| <b>Subject</b>          | UNSW G25 Education Building - SSDA Updated Stormwater Discharge Strategy (SSD-74670005)                                                                                                                             |

This document serves as an addendum to the previously issued UNSW G25 Education Building Civil Design Report (UNSW G25-ARP-REP-CI-0004[04]) which was prepared in support of the State Significant Application SSD-74670005). It addresses updates to catchment delineation and stormwater discharge points from the proposed development subsequent to SSDA submission. This update concerns SEARs Requirement 14 – Water Management, shown in Table 1.

Figure 1: E25/G25 Stormwater Catchment Reconfiguration

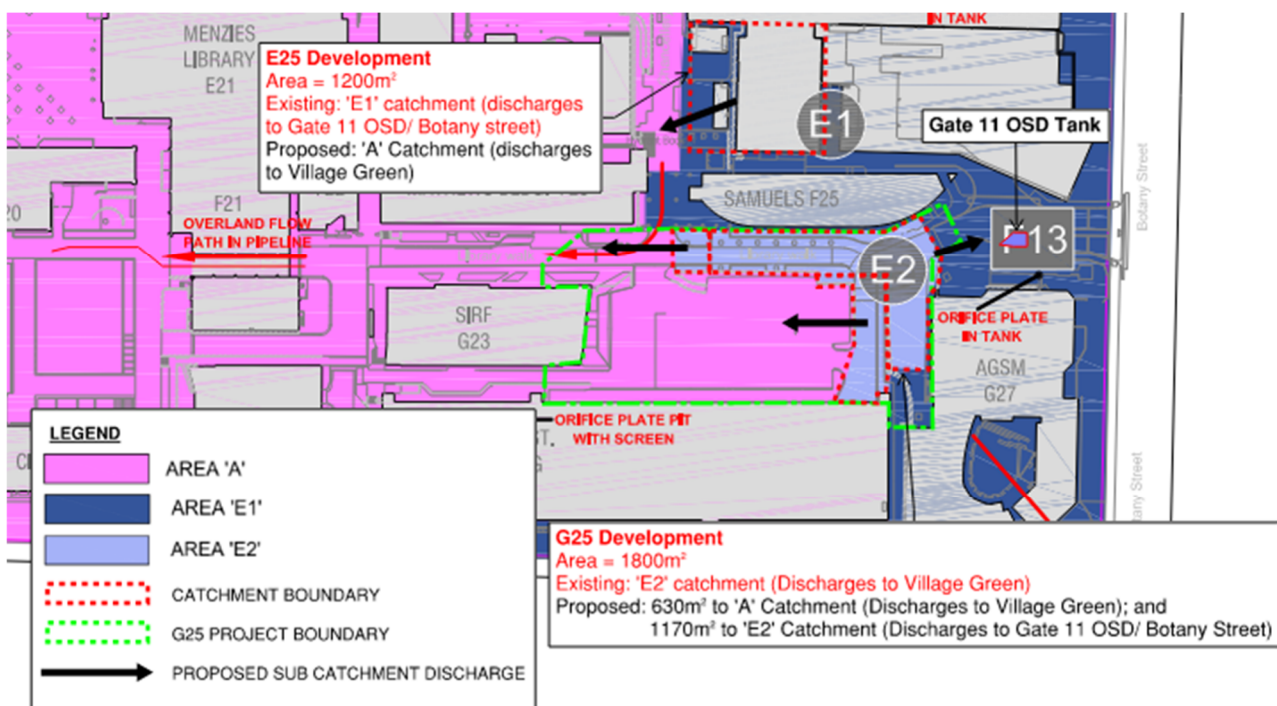
Subsequent to this design being prepared, UNSW advised of a proposal to alter the stormwater reticulation of the adjacent E25 development and therefore redefine the sub catchment delineation.

The adjacent E25 development (falling under ‘E1’ sub-catchment) is located to the north of G25 and is currently draining to the Gate 11 OSD tank with discharge to Botany Street. The new design for E25 re-directs the roof drainage and ground level hardstand to the Chancellery Walk stormwater system which outfalls to the Village Green infiltration tank (Catchment ‘A’). This reconfiguration frees up storage capacity in the Gate 11 OSD to receive flows from the ‘E2’ catchment which currently drains to the Village Green.

A comparison of the sub-catchment alterations has been completed, with E25 development at 1200m<sup>2</sup> and the ‘E2’ catchment at 1800m<sup>2</sup>. As shown in Figure 1, 630m<sup>2</sup> of catchment ‘E2’ will continue to discharge to the Village Green infiltration tank, whilst 1170m<sup>2</sup> will be redirected to the Gate 11 OSD tank and Botany Street. This new 1170m<sup>2</sup> catchment discharging to Gate 11/ Botany Street is intended to offset the 1200m<sup>2</sup> change arising from proposed E25 discharge strategy.

Drawing Title  
**STORMWATER  
CATCHMENT  
PLAN**

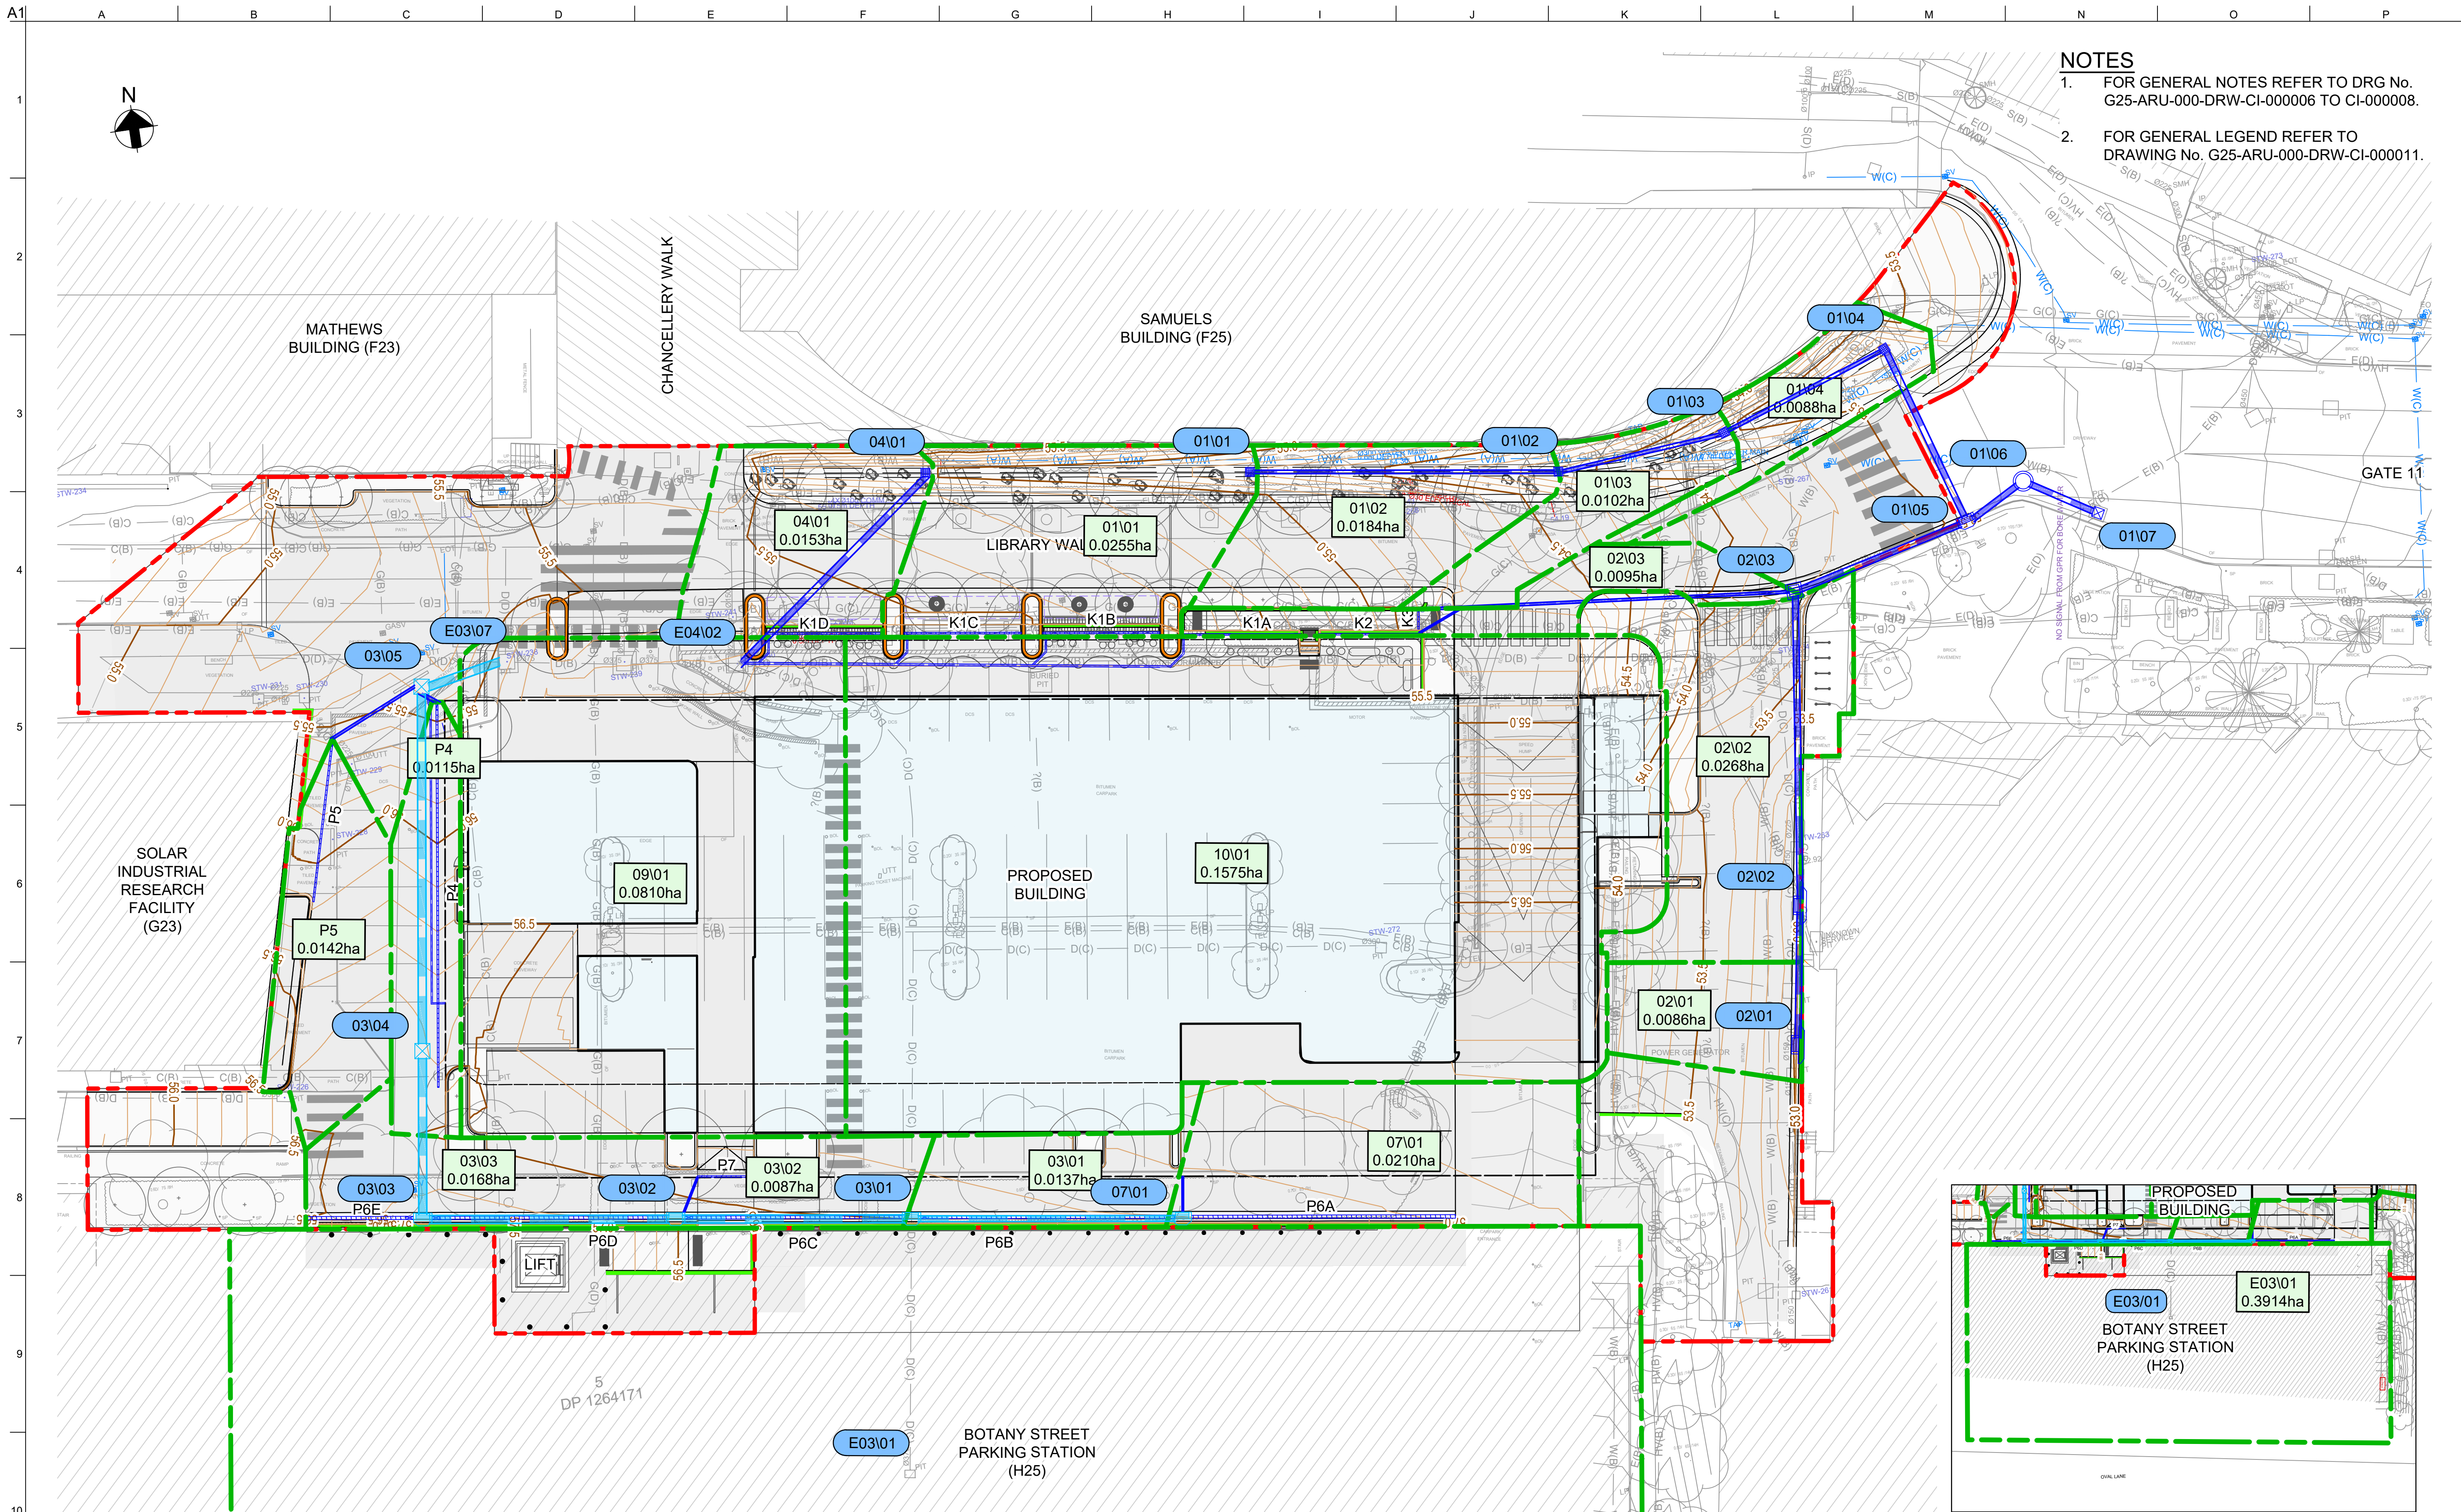
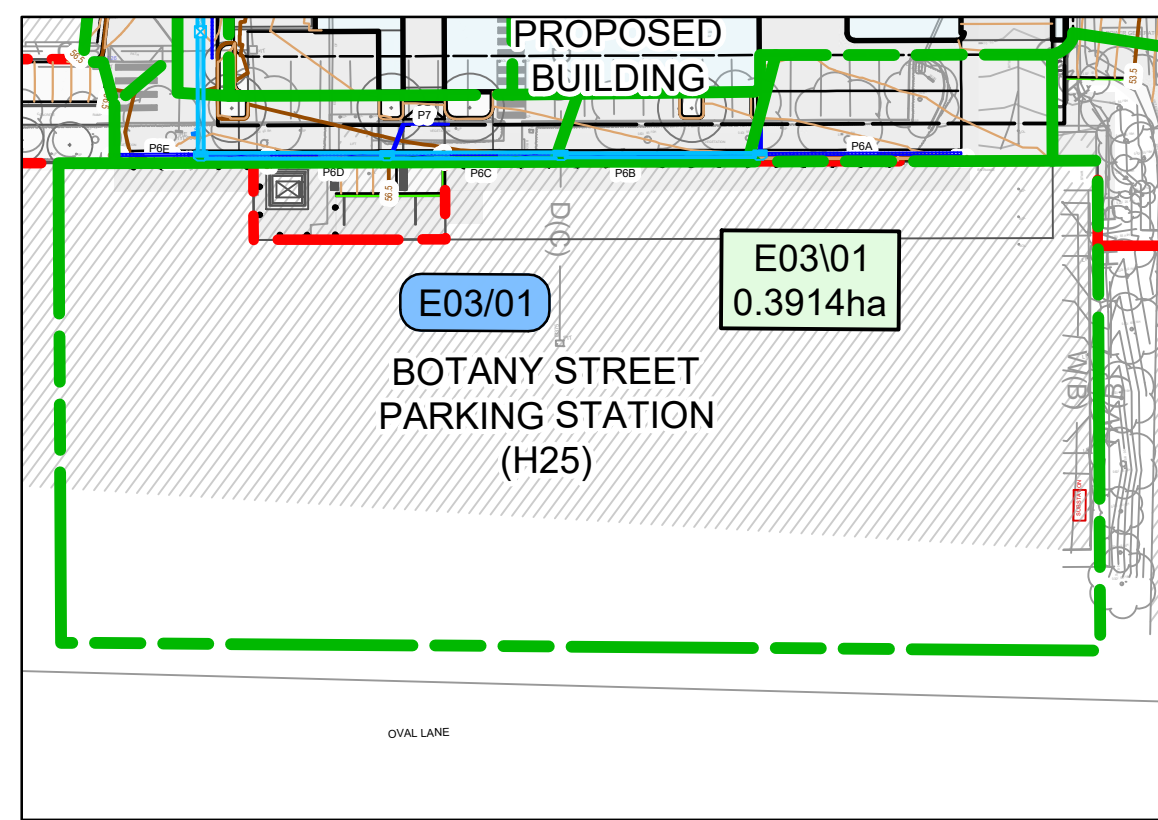
change the total catchment areas to each point of discharge. An extract of the updated stormwater plan and catchment plan are provided in Appendix A.

REFER INSET  
CATCHMENT E6-1 CONTINUES TO THE SOUTHERN EXTENT OF THE BOTANY STREET PARKING STATION
